Appendix B - A copy of the relevant parts of the decision

12 QUEENSTOWN TOWN CENTRE

QUEENSTOWN LAKES DISTRICT COUNCIL

Hearing of Submissions on Proposed District Plan

Figure 1: Identified Pedestrian Links

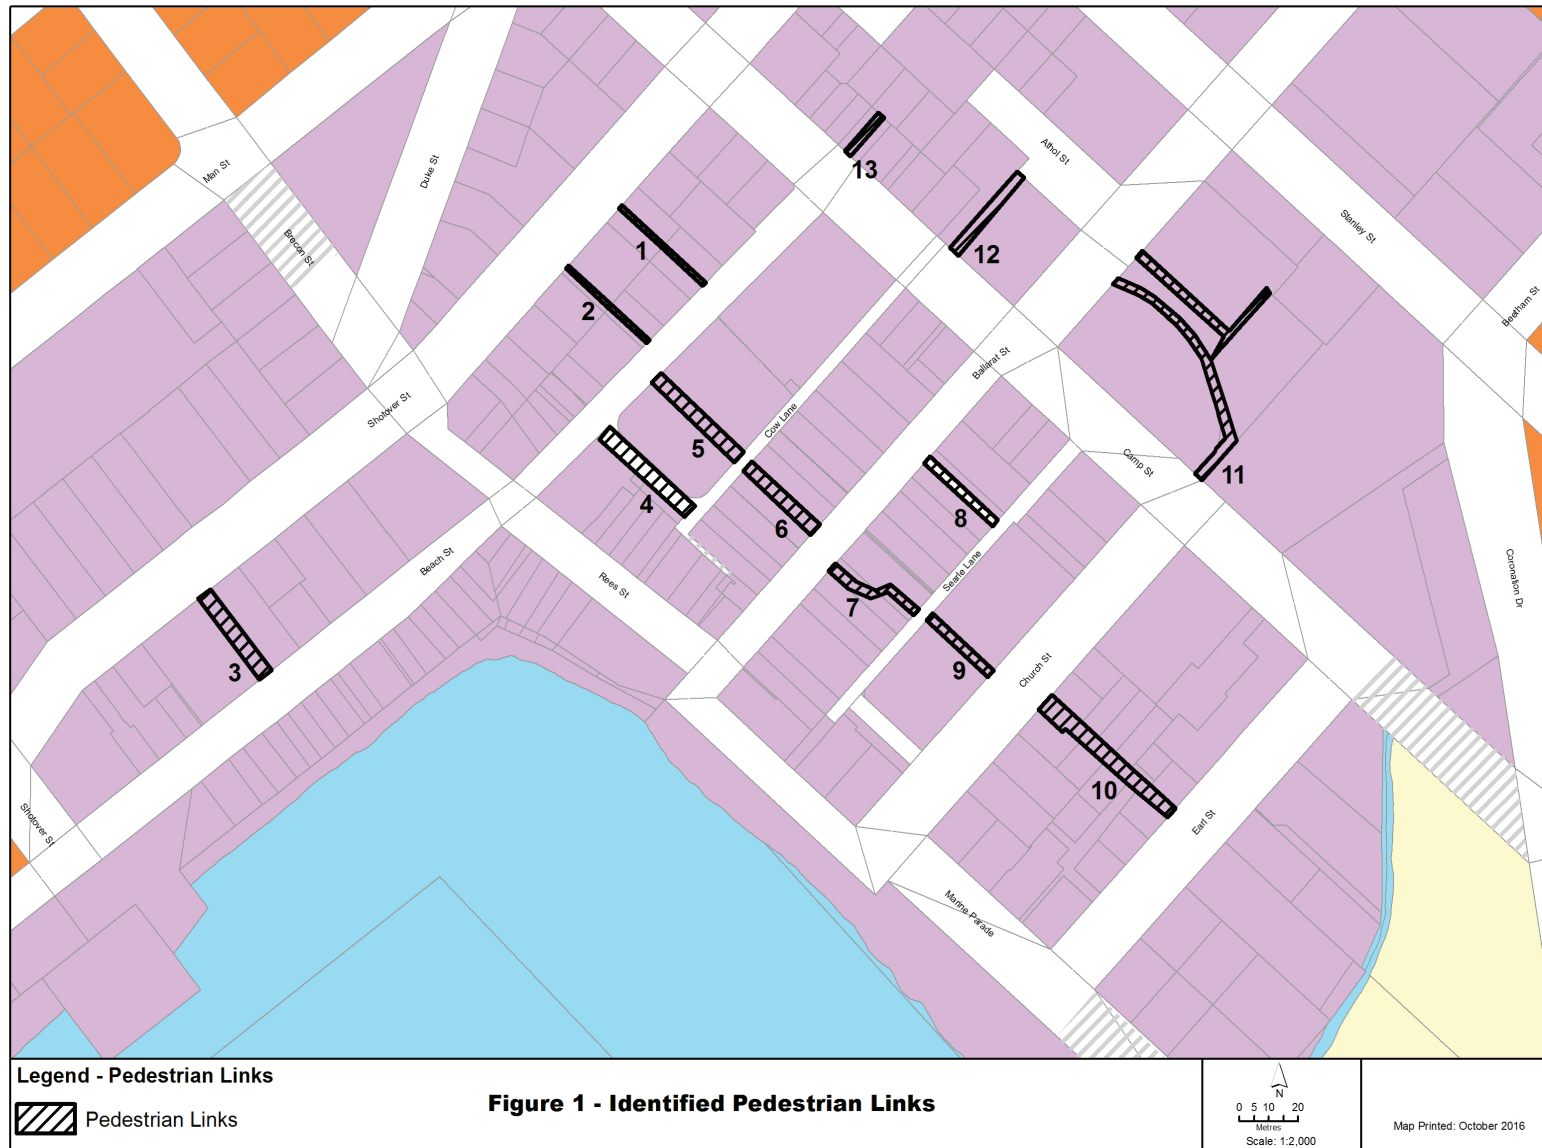
492. Peter Fleming³⁷⁰ sought that the pedestrian link map include legal descriptions on sites over which pedestrian links were provided. Tweed Developments Limited³⁷¹ considered that the notified Rule 12.5.8 and Figure 1 should also include pedestrian connections provided as a result of covenants and agreements between the Council and property owners.

494. Ms Gillies was very clear in her opinion that any existing pedestrian links should be retained.³⁷³ She was less certain on whether or not new links should be open to the sky or closed. She agreed Figure 1 (showing the existing pedestrian links) was inaccurate and should be updated.³⁷⁴ She supported new pedestrian links being encouraged as part of new developments. However, she did not think intended or proposed links should be shown on the PDP maps.³⁷⁵ She considered that new links should evolve from an assessment of the relevant site and after careful regard of design issues arising.

501. Following consideration of the submissions and the expert evidence of Ms Gillies and Mr Church, Ms Jones made a number of recommendations:³⁸⁷
- a. Correction of the notified pedestrian link map, Figure 1, so as to improve the map, accurately capture related legal descriptions, and ensure that all formal existing laneways in pedestrian links were included;

519. As to the submitters' concerns that including existing pedestrian links on Figure 1 within the PDP would amount to a *de facto* designation without providing them access to compensation, we find that we disagree.

530. Christine Byrch⁴²¹ neither supported nor opposed notified Figure 2 and therefore we recommend this submission be rejected.
531. Notified Figure 2 was included in Chapter 12 as follows:

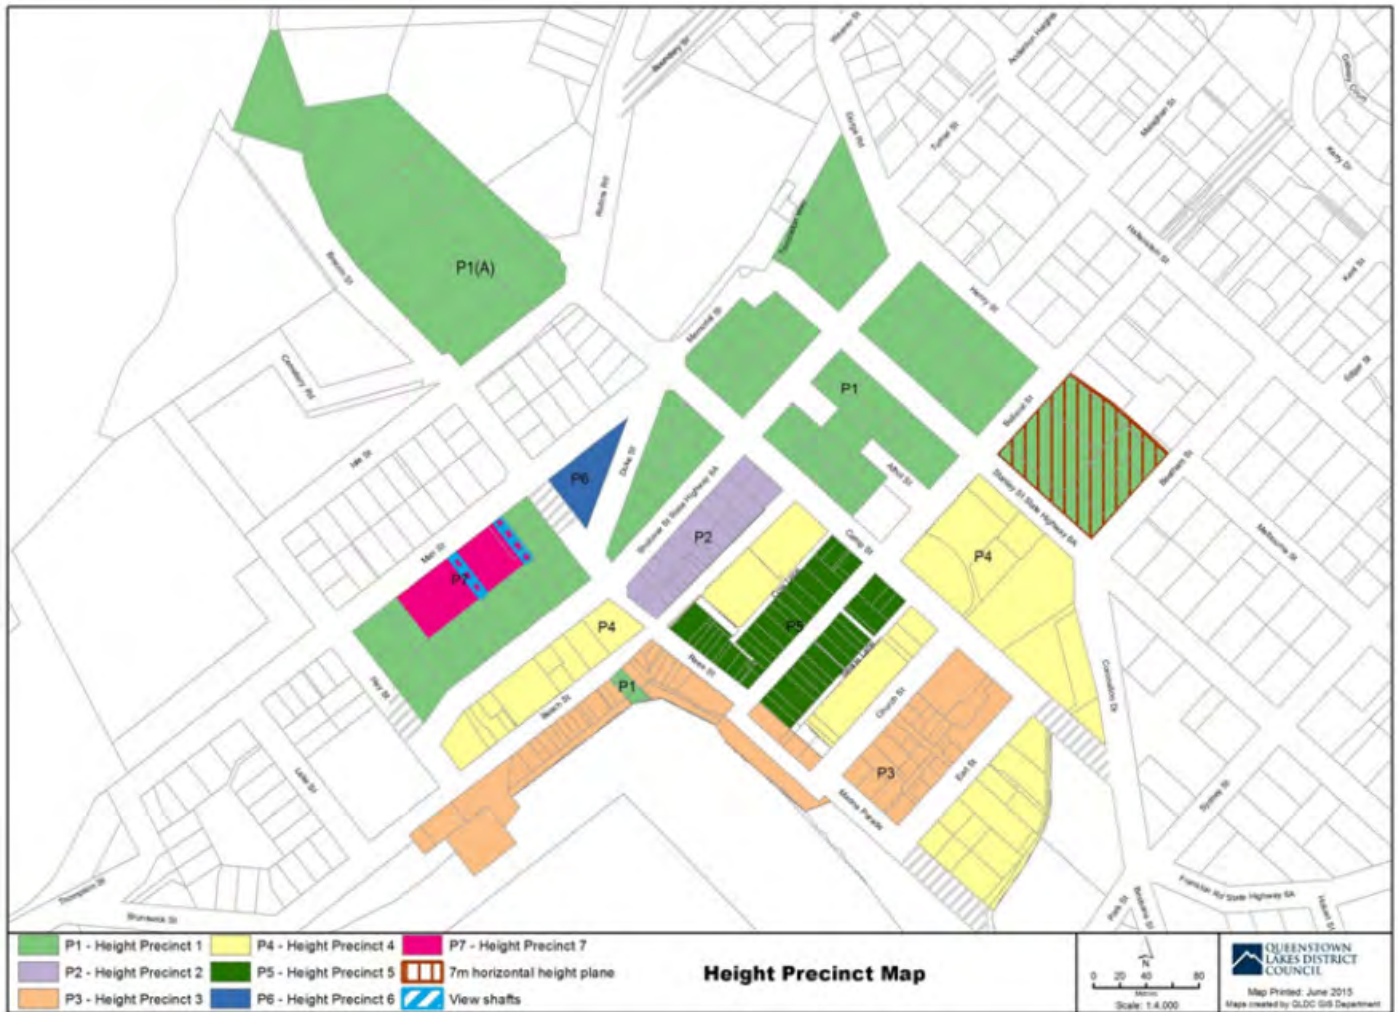
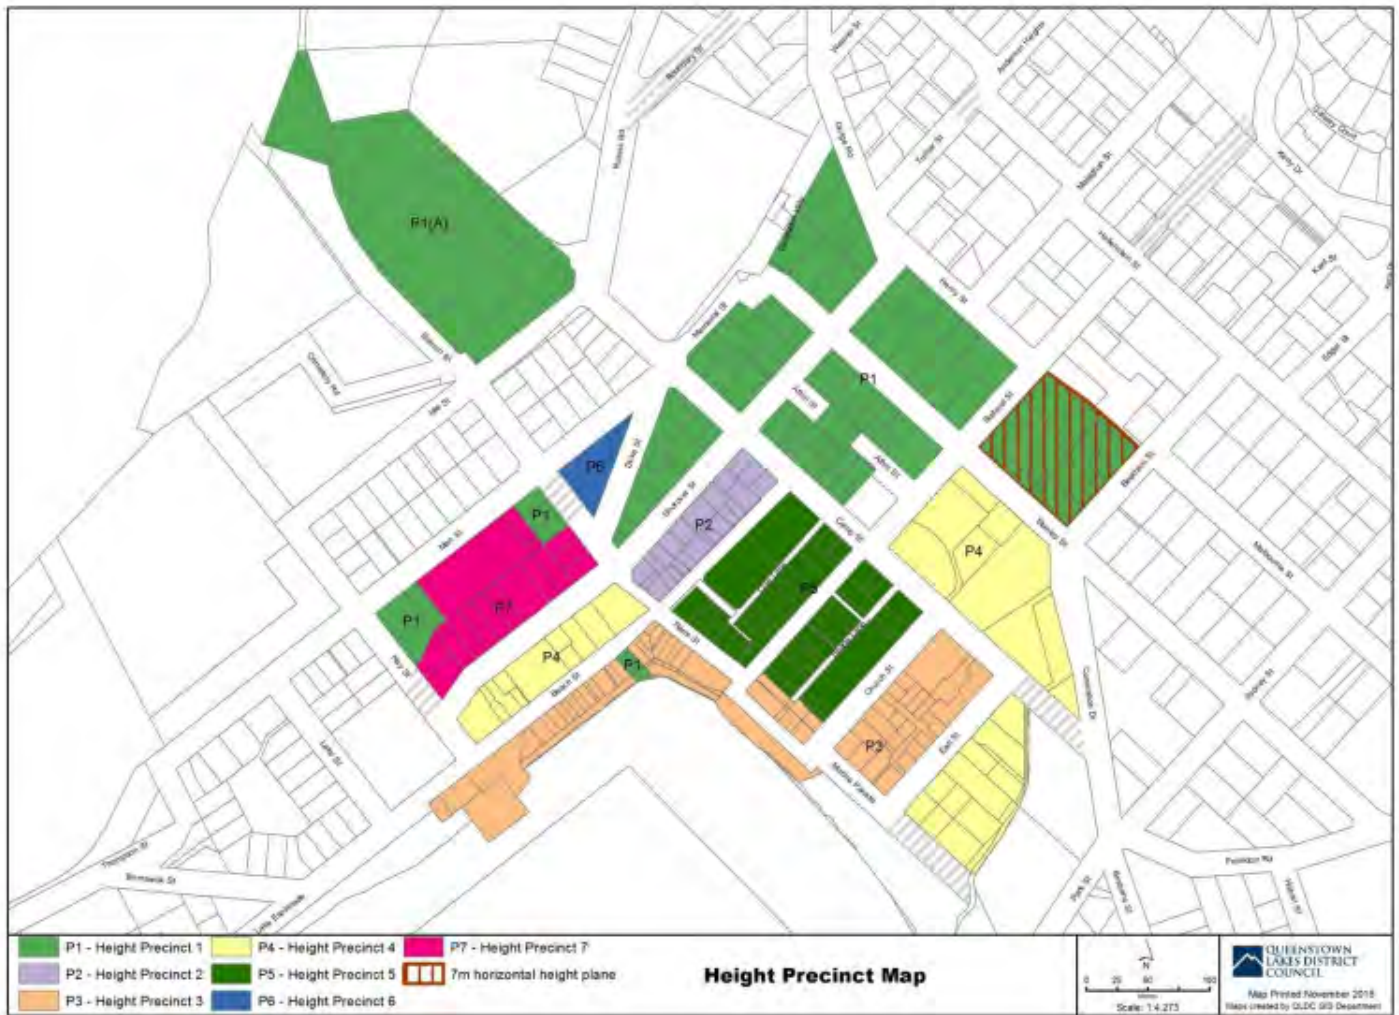
529. Rules 12.5.9 and 12.5.10 both referred to the Height Precinct Map, Figure 2, which identified the height precincts and their locations. We will refer to this throughout our report as Figure 2, and identify which version we refer to. In addition to this, we include Figure 2 in the following discussion in order to aid the reader in understanding how the height precincts and rules evolved through the hearing process.

532. While out of chronological order, we note here the version of Figure 2 attached to Ms Jones Section 42A Report was inserted by error. Prior to the hearing, by memorandum of 8 November 2016, a version of Figure 2 consistent with the recommendations in her Section 42A Report, was circulated to all participants. That Map contained the following amendments to the Precincts:
- a. Precinct 7 was extended down to Shotover Street to include the majority of the Man/Hay/Shotover/Brecon Street Block
 - b. Precinct 5 was extended to include those parts of the south side of Upper Beach Street and the North side of Church Street, which were shown as Precinct 4 in the notified version
 - c. That part of Precinct 3 between the Mall and Church Street was extended north-east to include the adjacent sites.

Reply Figure 2

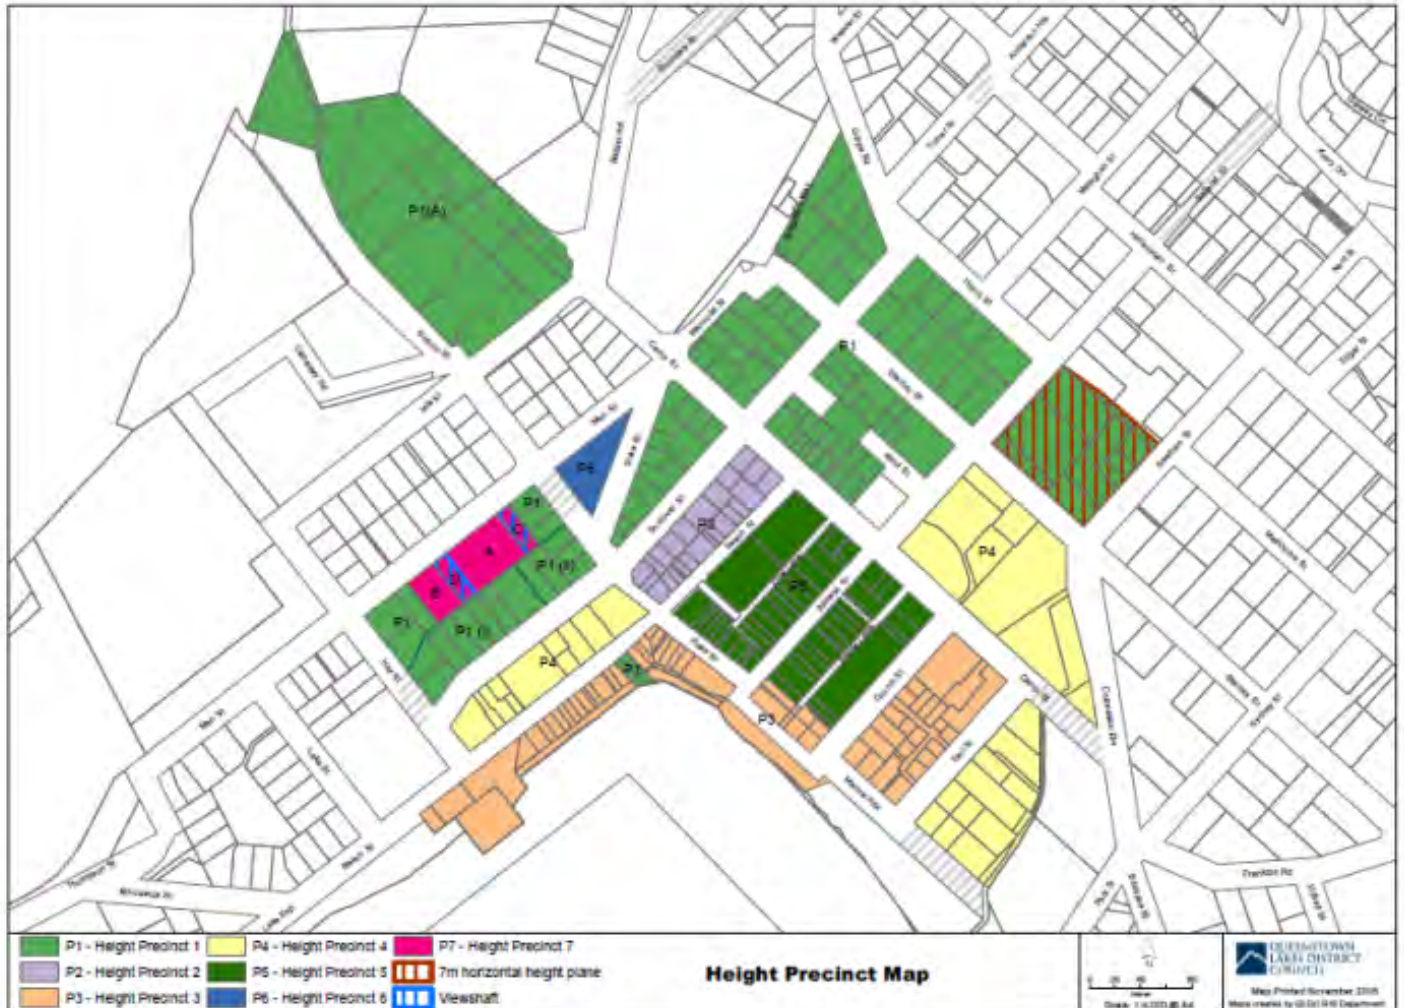
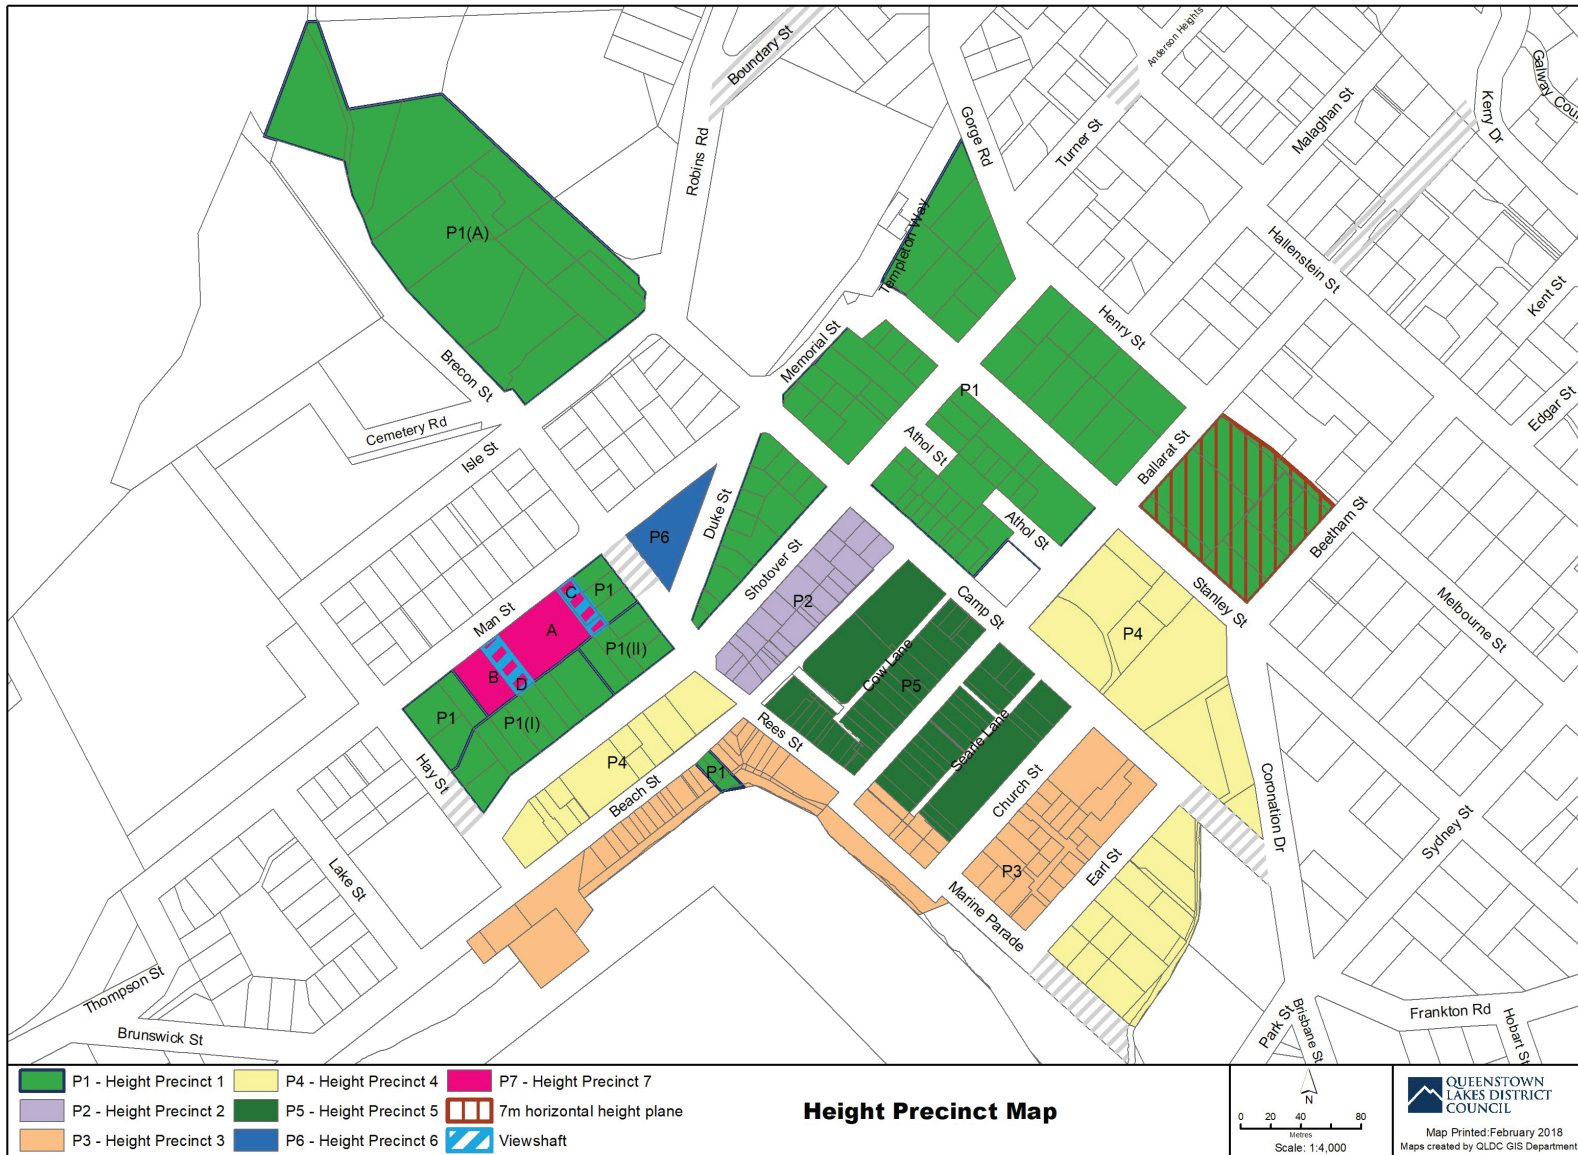
681. In her Reply⁵⁶¹, Ms Jones responded to Mr Farrell's evidence and questions, by recommending that Areas E and F (as shown in notified Figure 2) be removed from Precinct 7 and replaced with Precinct 1, and consequential changes be made to Rules 12.5.10.4 and 12.5.10.1. These consequential changes included adding a rule to 12.5.10.1 that no building exceed a horizontal plane at 271.1/ 330.1 masl. The recommended rules in Appendix 1 to her Reply Statement would have the effect of providing the restricted discretionary activity status to buildings between 12 and 14m above ground level as in the rest of Precinct 1, while ensuring that anything above either 14m above ground level or 271/ 330 masl respectively would be non-complying. She considered this to be more efficient and effective than redraft Rules 12.5.10.4(e) and 12.5.10.4(f) that applied to this area in the version attached to the Section 42A Report.

698. The final issue with the view shafts related to queries we raised during the hearing about whether the view shafts should be movable or their shape able to be altered. Ms Jones was of the view that she did not consider this to be necessary as the eastern view shaft was set, and she reminded us that there were limited alternate locations for the western view shaft. Overall, she preferred fixing their position on Reply Figure 2.

684. Included in Ms Jones' Reply Statement was her final recommended Figure 2 (Reply Figure 2). We include this below in order to aid in understanding the recommendations that follow. Reply Figure 2 is also included in our recommended Chapter 12 set out in Appendix 1.

701. We agree with the evidence of Mr Williams and Ms Jones on this point and accept Ms Jones' reasoning for the change in the location of the western view shaft. We recommend adoption of this change as shown on Reply Figure 2.

734. We recommend these rules be renumbered as Rule 12.58 and Rule 12.5.9, and be adopted with the wording set out in Appendix 1. This wording incorporates necessary consequential changes resulting from the revisions we have discussed above. We also recommend including as Figure 2 the Height Precinct Plan shown as Reply Figure 2 above.
